Title:	Wiring Splitting Power Supply				ID:
				0094	
Date in:		Response:	Model:	Author:	
2009-03-10		2009-03-10		RKi

## **Wiring Splitting Power Supply**

Wire on power supply

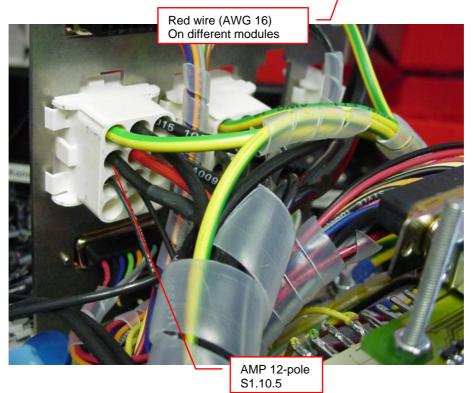
Remove red wire (AWG16) between power supply +V and S1.10.5

## Preparing new wire

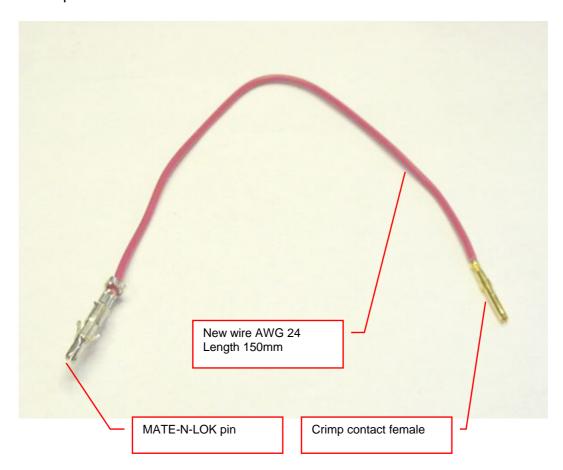
- 1x Wire AWG 24 red, length 150mm
- 1x MATE-N-LOK pin
- 1x D-Sub crimp contact female

## Add new wire between C103.5 and S1.10.5
